Airworthiness Directive

Docket No. 89-ANE-21; Amendment 39-6427; AD **90-04-06** R1

TEXTRON LYCOMING Models All Textron Lycoming Four Cylinder Piston Engines
PDF Copy (If Available):

90-04-06 R1 TEXTRON LYCOMING: Amendment 39-6427 as revised by Amendment 39-6915.
Docket No. 89-ANE-21.

Figure 1. Propeller Governor Line Support PART 1

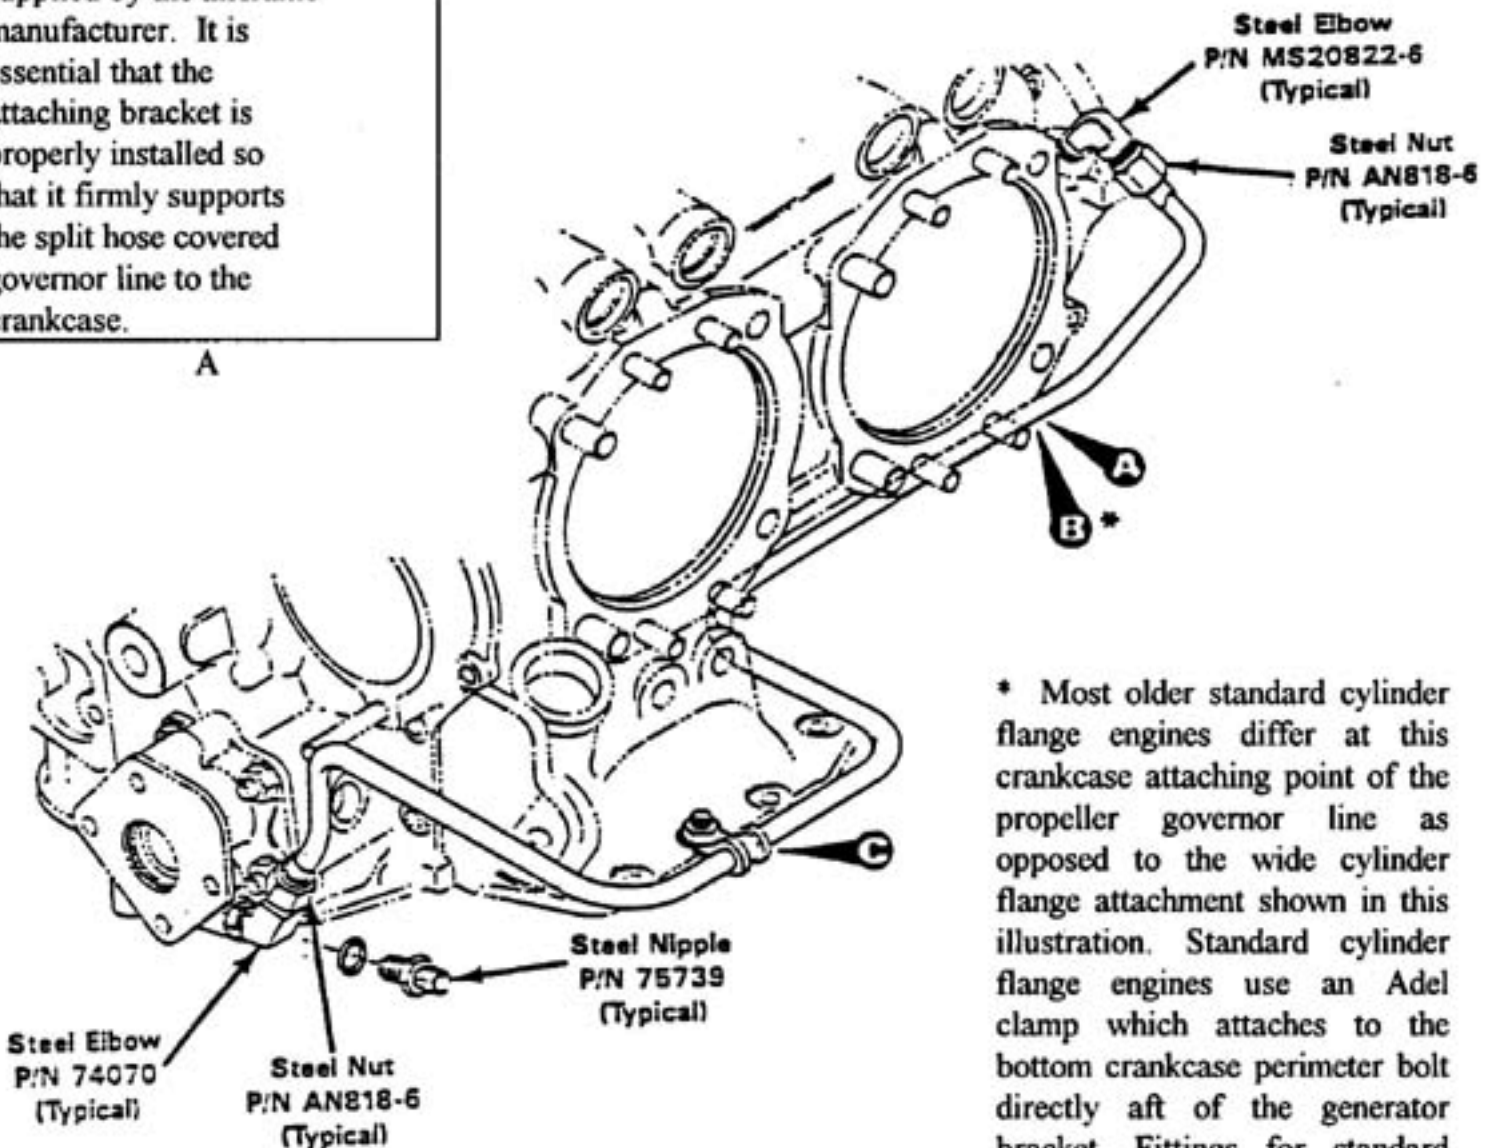
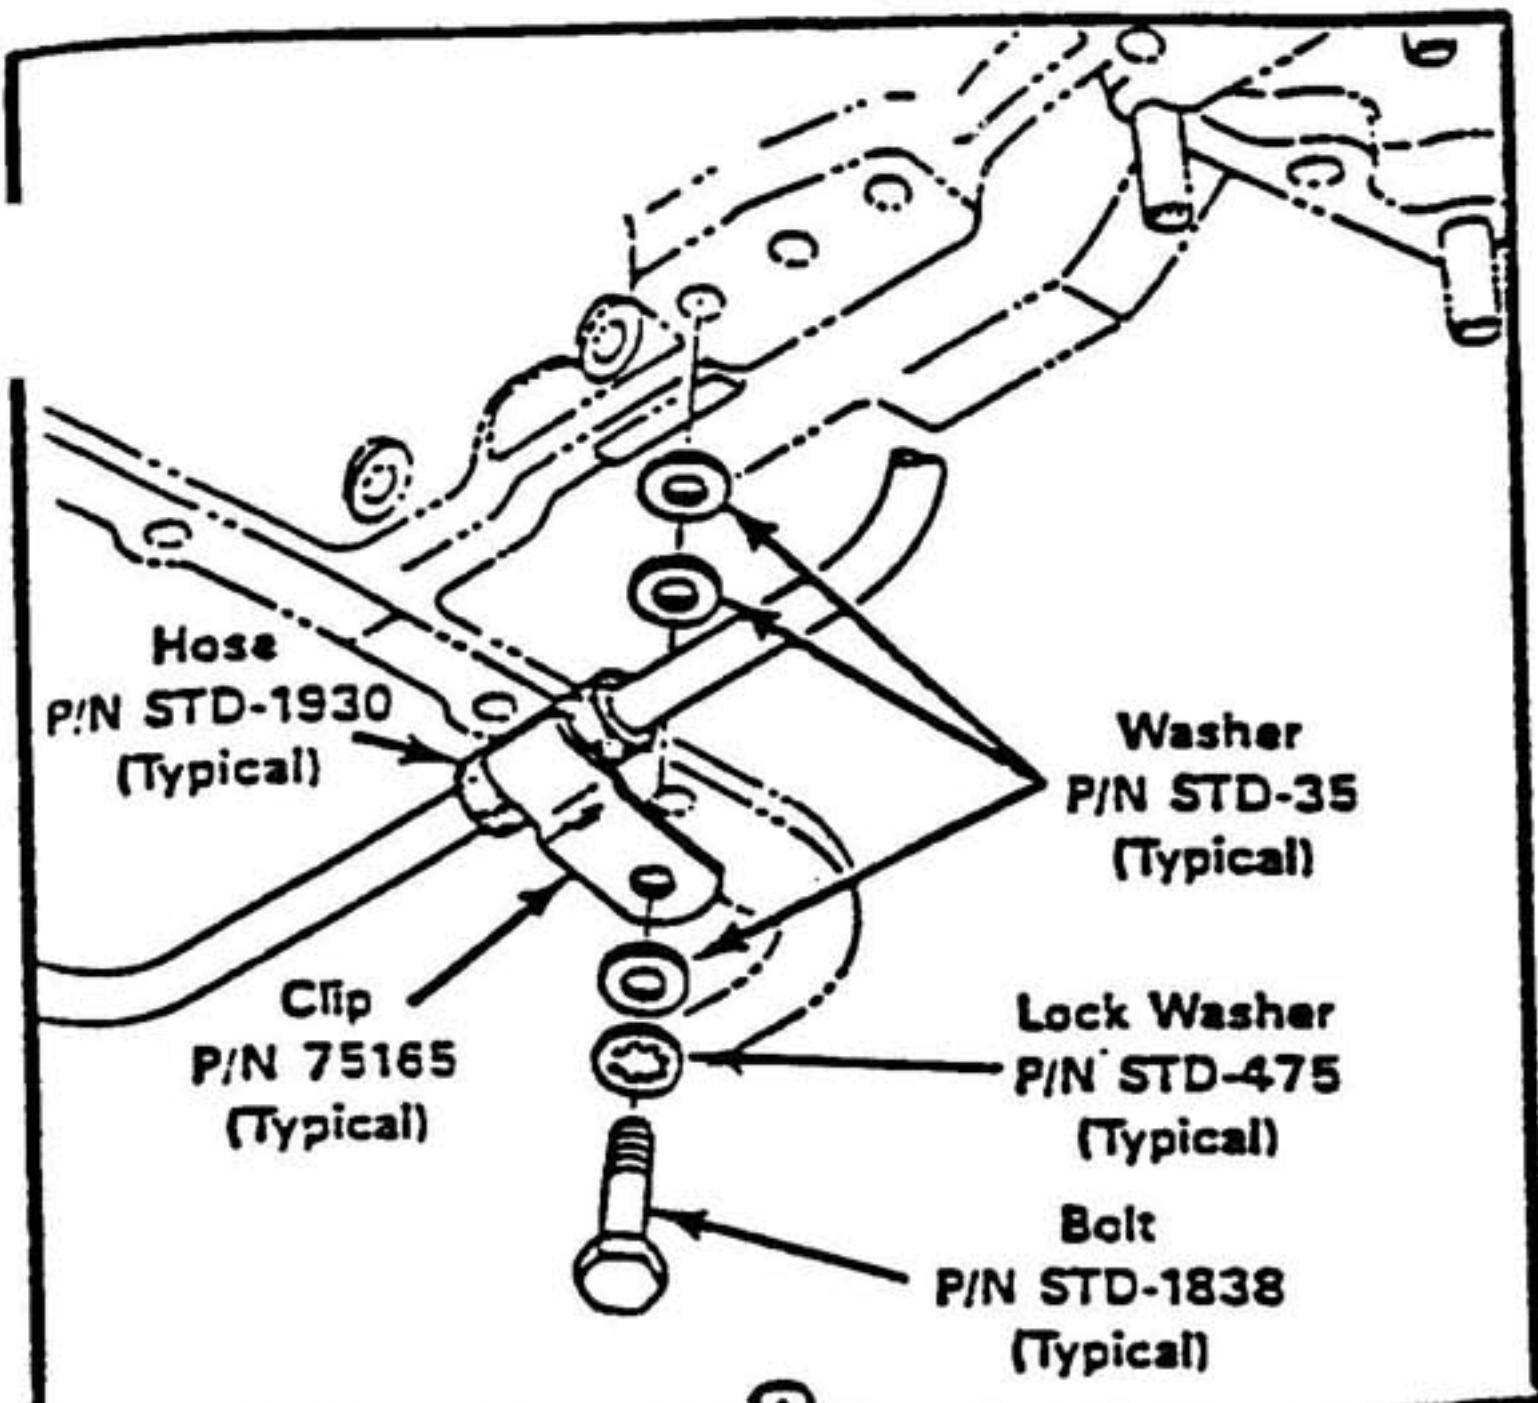
(1) Inspect the propeller governor external oil line for abrasions, cracks, and oil leaks along the length of the line and at the end attachment fittings. Inspect to determine that the two cushion type support clamps or clips are properly installed as shown in Figure 1 of Appendix 1 to this AD, and assure that sufficient clearances exist between the oil line and adjacent components.

(2) If any leaks, chafing, or interference condition exists or if the two support clamps or clips are not properly installed, replace the governor oil line and its attachment end fittings with new parts even though the parts show no visible damage. Refer to Figure 1 in Appendix 1 to this AD, for parts identification, line routing, and location of support clamps or clips. The fittings in the engine case and governor must be replaced if they are damaged or are made of aluminum.

(b) At the next engine overhaul or anytime the governor oil line is removed for any reason, whichever occurs first, but no later than May 1, 1992, remove any governor oil line assembly having integral aluminum connecting nuts and reinstall an oil line assembly with corresponding steel connecting nuts. Replace any engine case/governor aluminum fittings with corresponding steel fittings as shown in Figure 1 of Appendix 1 to this AD.

* Most older standard cylinder flange engines differ at this crankcase attaching point of the propeller governor line as opposed to the wide cylinder flange attachment shown in this illustration. Standard cylinder flange engines use an Adel clamp which attaches to the bottom crankcase perimeter bolt directly aft of the generator bracket. Fittings for standard cylinder flange line may be -5

Bracket. Fittings for standard cylinder flange line may be -5 (5/16") instead of -6 (3/8"). Also, some earlier model propeller governor drives used 1/4" NPT fittings in the prop. governor adapter. If any of these fittings are found, replace with equivalent AN or MS steel fittings.

Figure 1. Propeller Governor Line Support PART 2

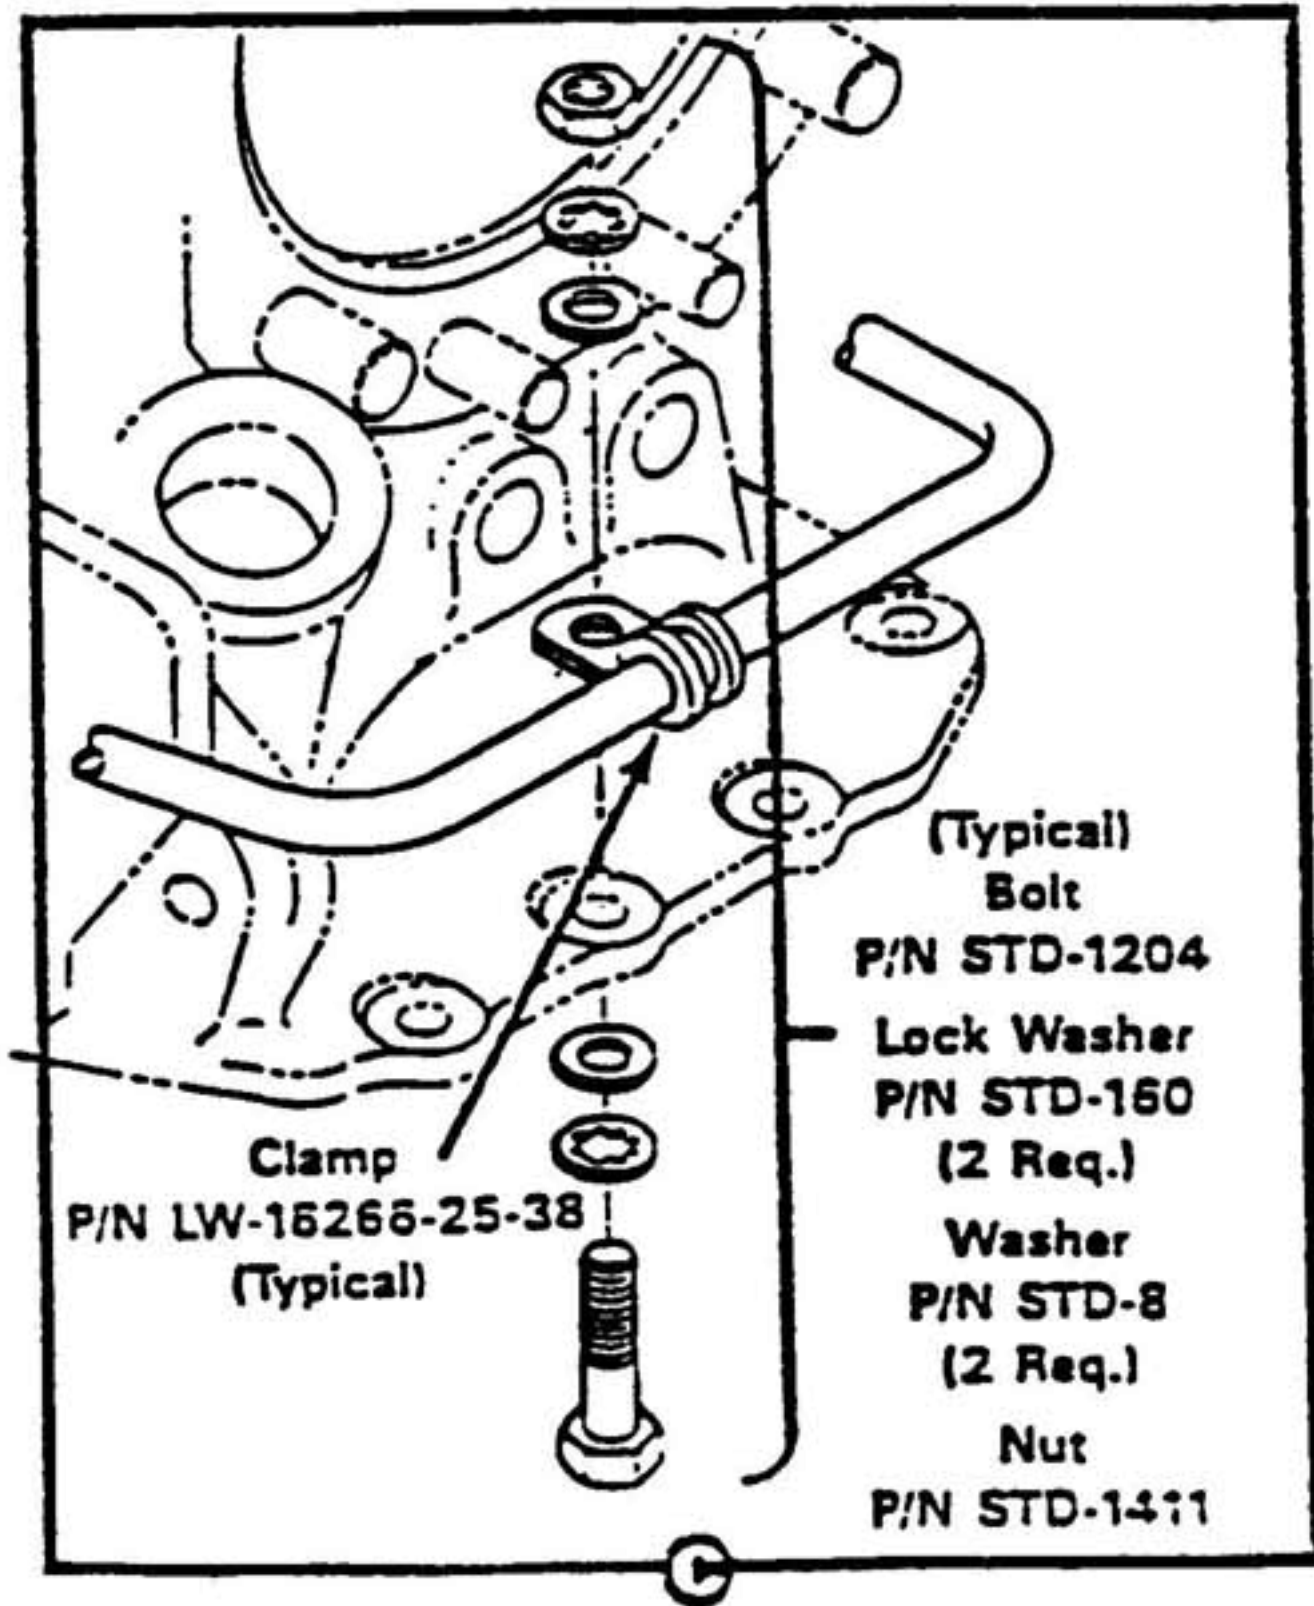
Textron Lycoming has approved the usage of the Piper Aircraft Corp. air conditioning bracket as a support of the propeller governor line. The split Hose P/N STD-1930 must still be used along with the bracket and hardware supplied by the airframe manufacturer. It is essential that the attaching bracket is properly installed so that it firmly supports the split hose covered governor line to the crankcase.

Figure 1. Routing, Fittings and Clamping Detail

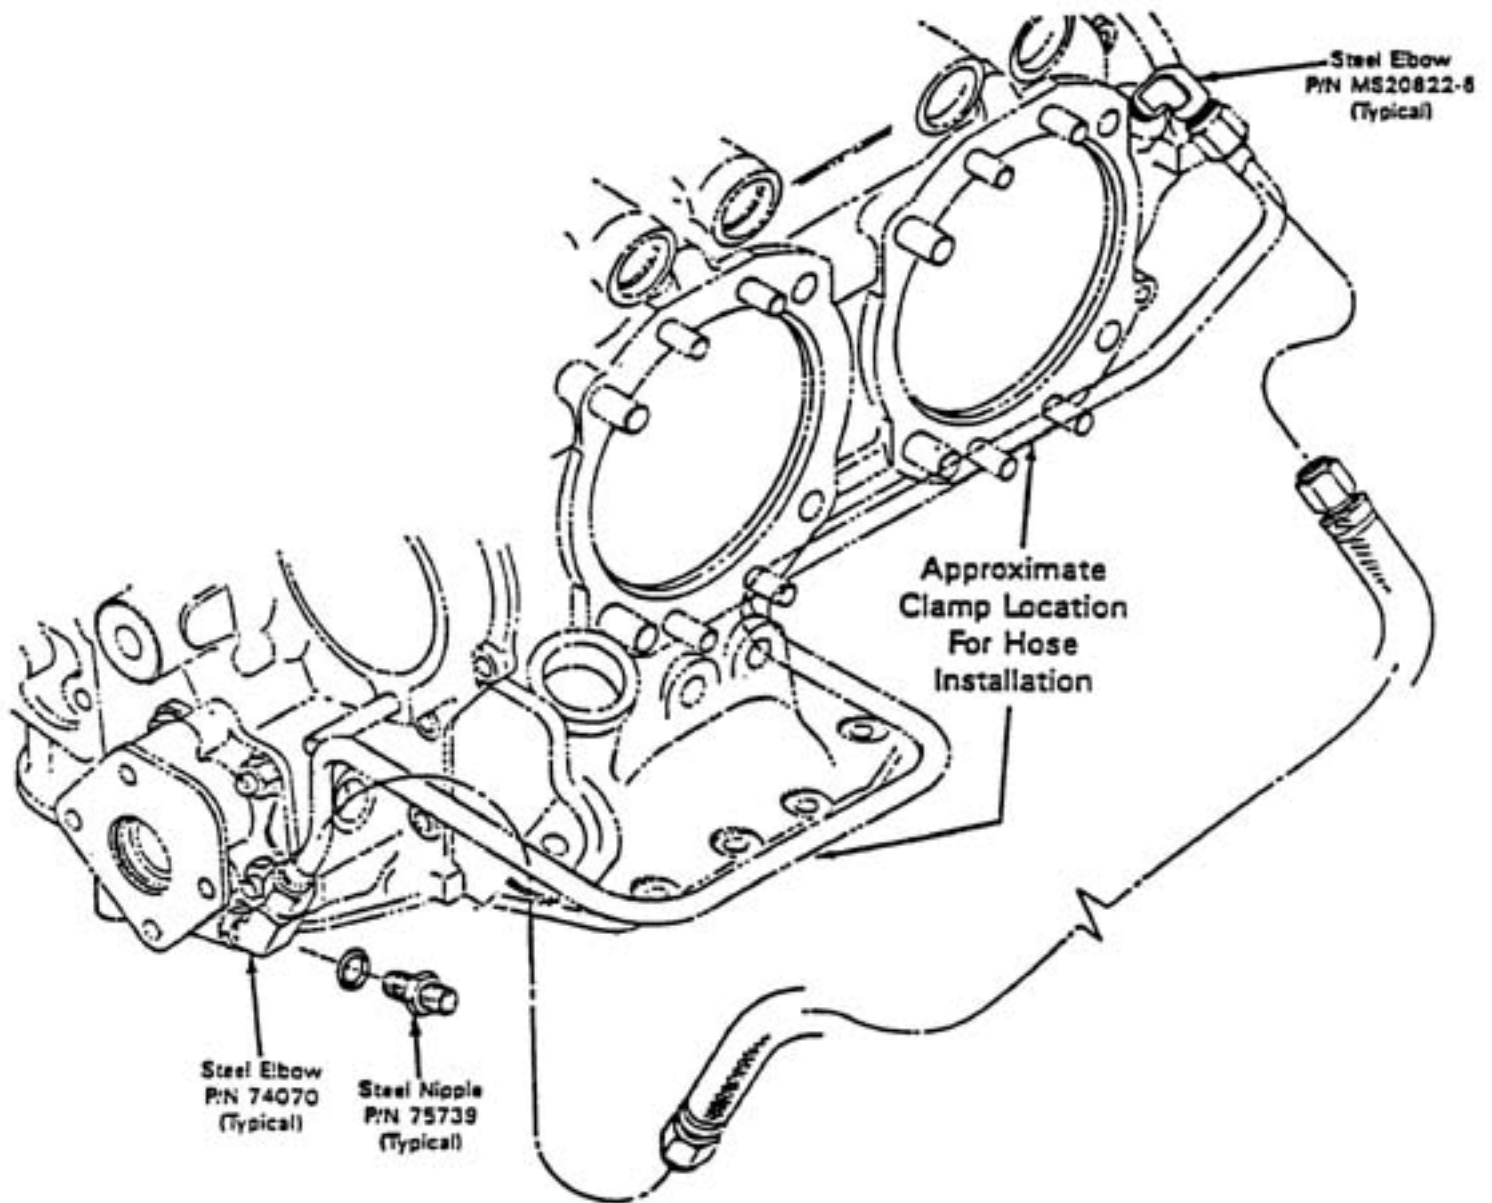
If -5 (5/16") fittings have been installed on some standard cylinder flange crankcase model engines, the propeller governor drive fitting and front crankcase fitting must be changed to the appropriate steel fitting to accommodate the new -6 (3/8") line. When re-installing new stainless steel tube assembly, appropriate -5 steel fittings must be re-installed.

IT IS MANDATORY THAT THIS FLEXIBLE HOSE BE REPLACED AT EACH OVERHAUL.

- a. Determine proper hose length as required for your particular installation.
- b. No sharp bends are permissible. Ascertain that no "kinks" exist while routing and clamping hose.
- c. Hose must not be routed near a heat source, such as any portion of the exhaust system.
- d. Hose is to be clamp supported to the engine (not to an airframe component) at a minimum of two locations.
- e. No clamping to cylinder head drain back tubes is allowed.
- f. After installation is complete, ensure that hose is not pinched. Make certain that engine motion during startup and shutdown does not pull or pinch the hose.
